**ADDENDUM No. 2**

**PROJECT NAME:** FIRE STATION # 32 REPLACEMENT, Project No. 20-00015  
**DATE:** March 3, 2015

**ADDENDUM NO. 02**

To the drawings and specifications for:  
Fire Station 32  
4839 Charles Katz Drive,  
San Antonio, Texas

**E101**

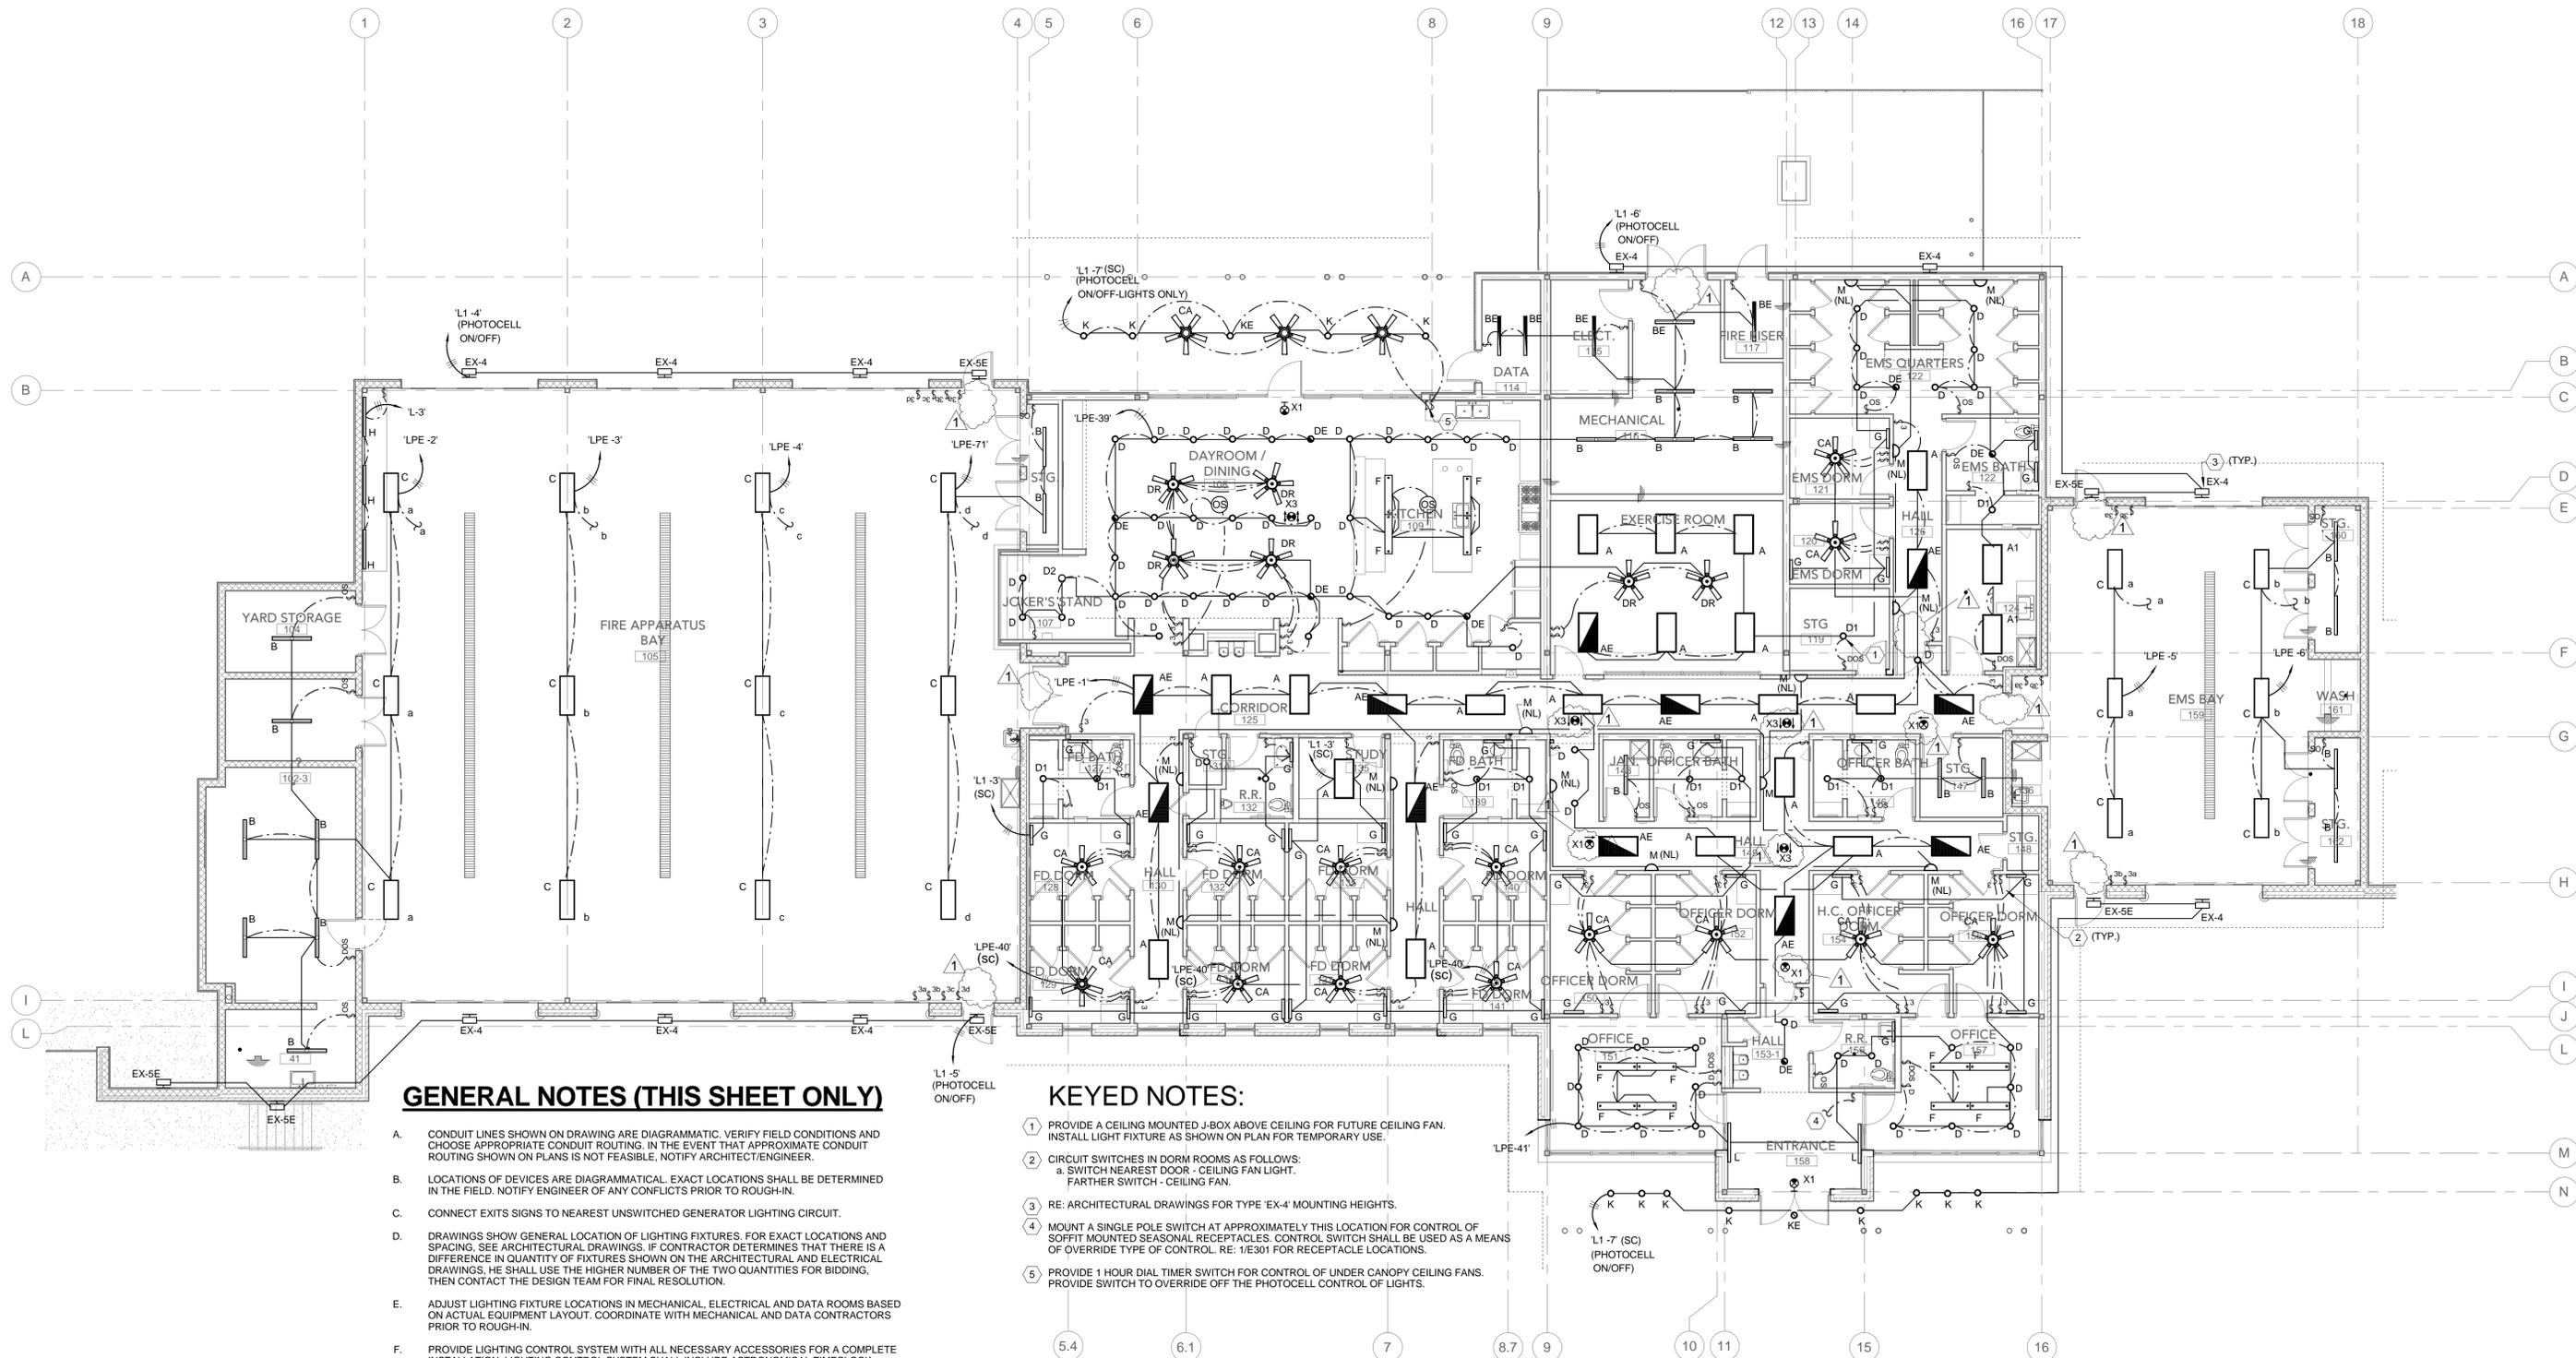
- 03 **Question:** Please provide location of the electrical service entrance (Detail 1/E601) on the overall site utility plan sheet C-2. Its location is not noted.

Item 2: Added keyed note no. 9 to reference the Electrical Service Entrance.

**Response:** Refer to revised Electrical drawing E101, keynote No. 9 for reference to the Electrical Service Entrance. Please see attached revised Electrical & Plumbing drawings from CNG Engineering.

**1 1ST FLOOR PLUMBING PLAN - WASTE AND VENT**  
1/8" = 1'-0"

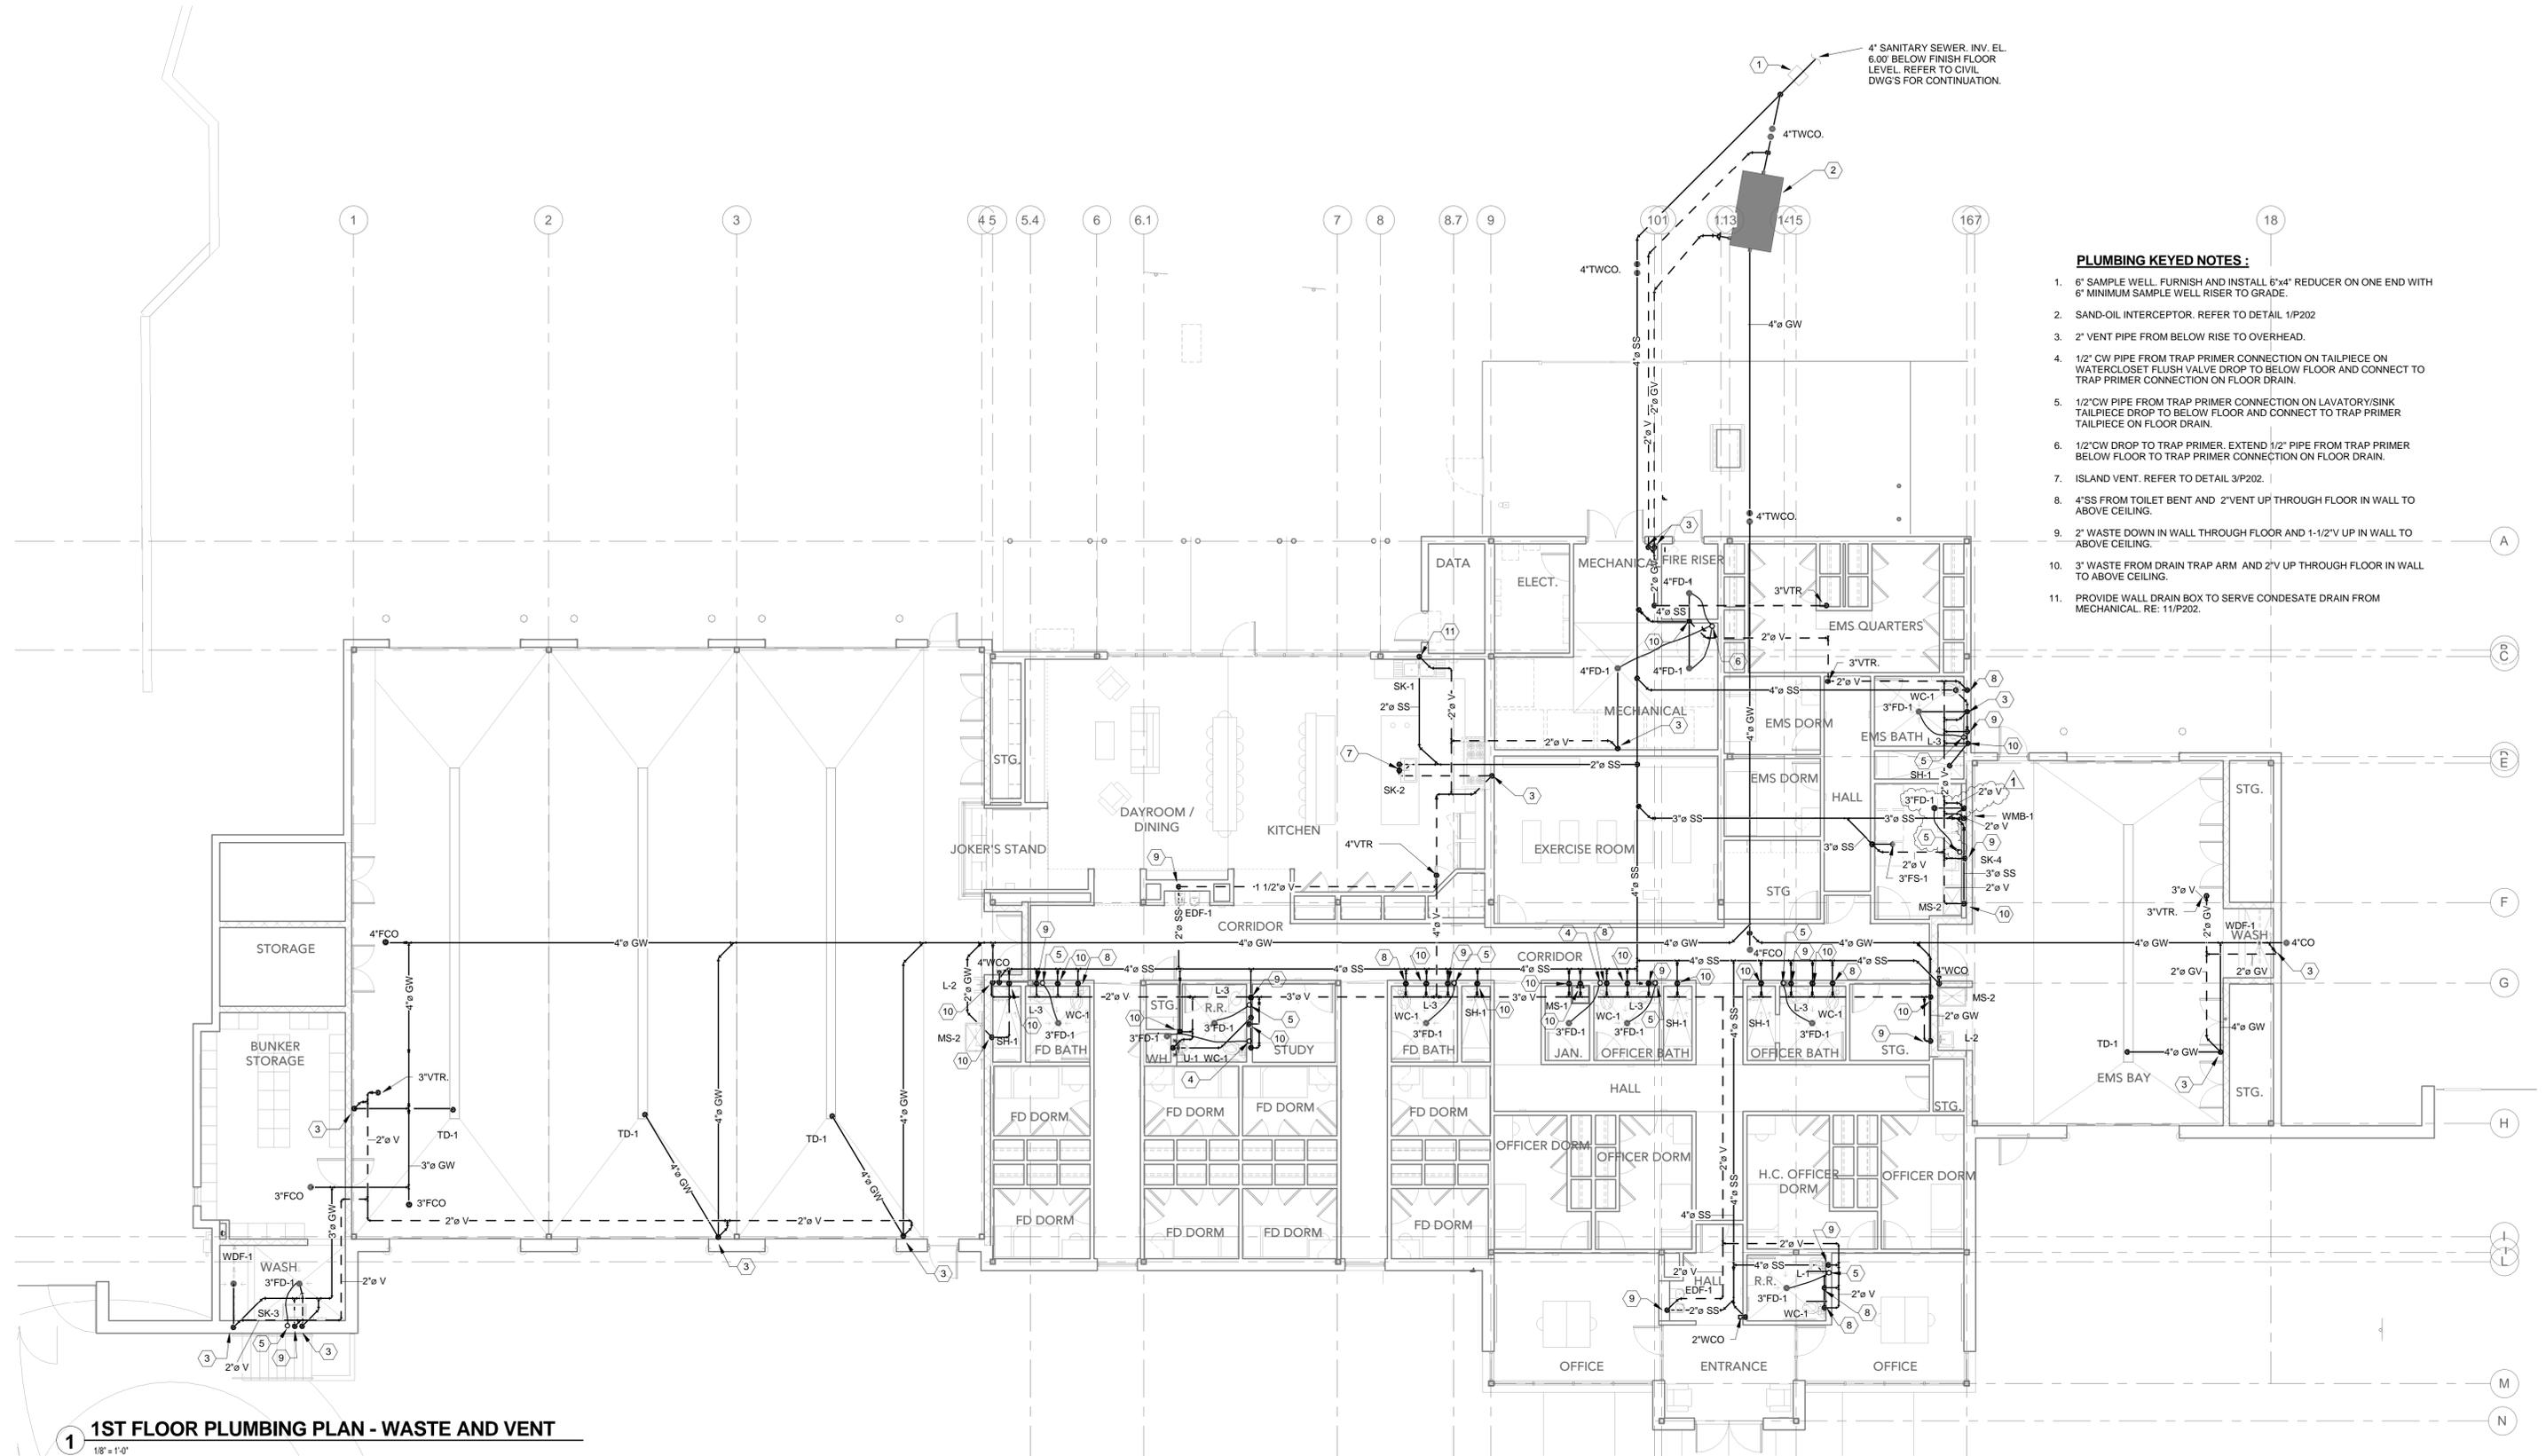
- Item 2.4** Laundry [124] floor finish updated from VCT to resinous flooring. Floor drain added adjacent to Washer/Dryer. Refer to updated sheets A4.2 & P101 Seal dated 03.02.15.

Item 1: Added floor drain in laundry room.
